# UNITED STATES PATENT AND TRADEMARK OFFICE

| APPLICATION NO. | FILING DATE | FIRST NAMED INVENTOR | ATTORNEY DOCKET NO. | CONFIRMATION NO. |
|-----------------|-------------|----------------------|---------------------|------------------|
| 10/590,982      | 08/28/2006  | Ikuo Mimura          | 00250.000036.       | 2590             |

| <b>Office Action Summary</b> | <b>Application No.</b><br>10/590,982 | <b>Applicant(s)</b><br>MIMURA, IKUO |  |

## DETAILED ACTION

**Fig. 1**

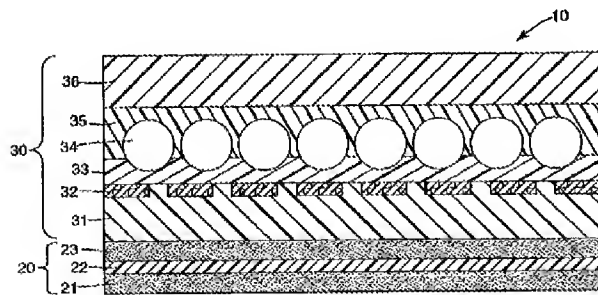
With regard to claim 1, Hingsen-Gehrmann et al. disclose the devices of Figures 1, 2, and 5.

The device is comprised of a surface protective **70**, an information display layer **60**, a light-reflective resin sheet **30**, and a substrate adhesive layer **20** [0034]-[0052], [0069] and [0079]. There is a specular reflective layer **31** that is apart of the light-reflective resin sheet **30** that has a destructive layer **32** installed on one side thereof, and the device is installed on an installation substrate **90** via the substrate adhesive layer; further, when the device is tampered with it results in the structure seen in Figure 2 [0072]. There is a destructive effect wherein separation takes place between the destructive layer and one of the other layers constituting the light-reflective resin sheet.

**Fig. 2**

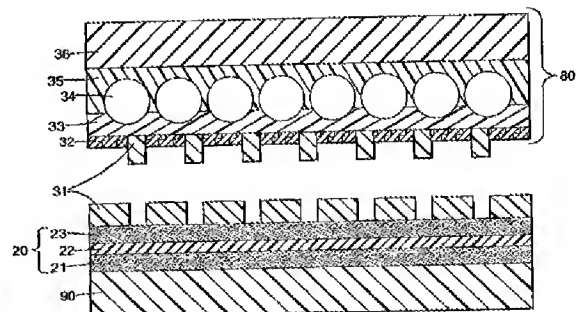
With regard to claim 4, as one can see from Figure 2 the destructive layer is partially installed in the light-reflective resin sheet, and also the specular reflective layer is partially broken and remains on the installation substrate.
